Item Name: Replacement Float Skidtube

DRAWING NO. D3391	TITLE 412 FLOAT SKIDTUBE	REV. H	DART AEROSPACE USA, INC ENGINEERING ORDER	D.E.O. NO. D3391-H-1	SHEET NO. SHEET 1 OF 1	SCALE NTS
DRAWN <i>JP</i>	CHECKED <i>J</i>		MFG. APPR. <i>AA</i>	APPROVED <i>MP</i>	DE APPR. <i>HP</i>	
DATE 09.09.23	DATE 09.09.24		DATE 09/09/25	DATE 09/09/30	DATE 09/09/30

LPS-3 IS NO LONGER USED DURING ASSEMBLY OF D3391-041/-043 SKIDTUBES.

D3391-043 ASSEMBLY

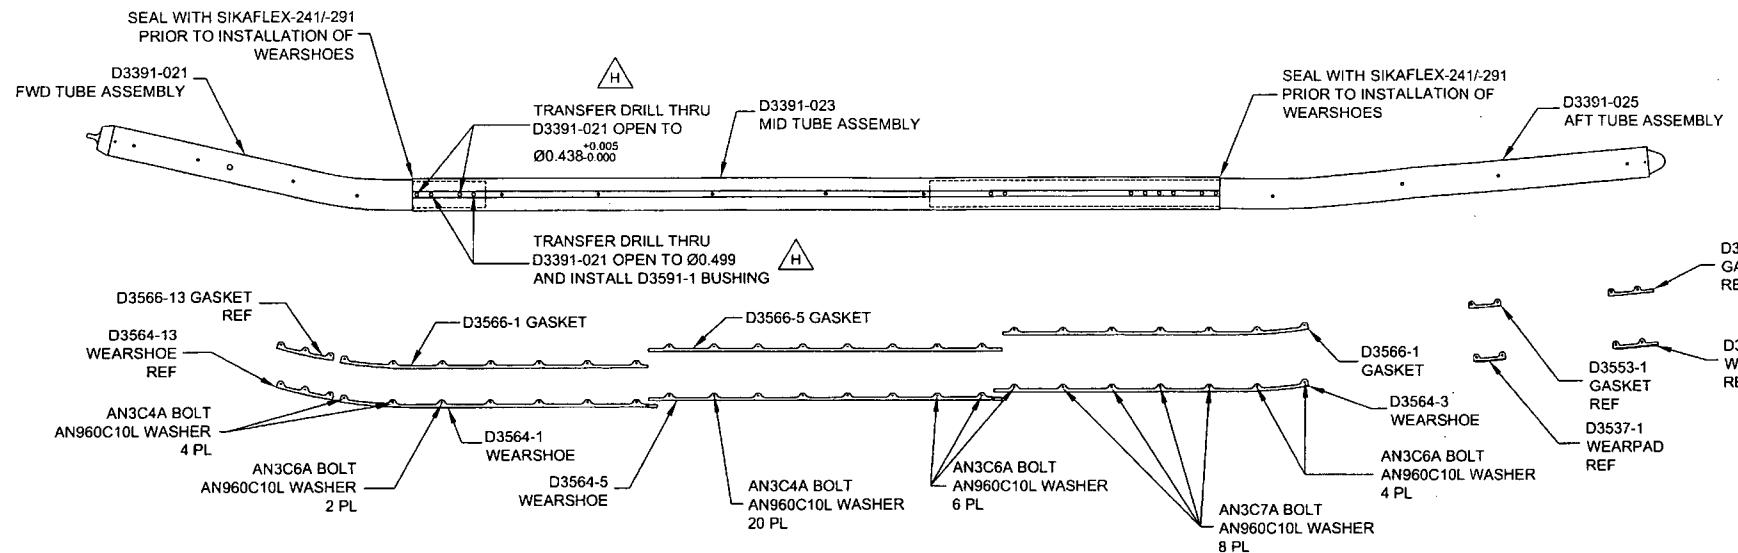
PURPOSE:

AMEND NOTE 2 OF D3391-041/-043 SKIDTUBE ASSEMBLIES (ZN A6-1, A6-2) AS FOLLOWS:

2) ~~SPRAY INSIDE OF TUBE WITH A COAT OF LPS LABORATORIES "LPS-3" AFTER FINISH
AND AFTER INSTALLATION OF INSERTS.~~ COAT ALL EXPOSED FASTENERS WITH
LPS LABORATORIES "LPS PROCYON" AFTER FINAL ASSEMBLY, CLEAN EXCESS
OFF POWDER COATING WITH MEK DEGREASER.
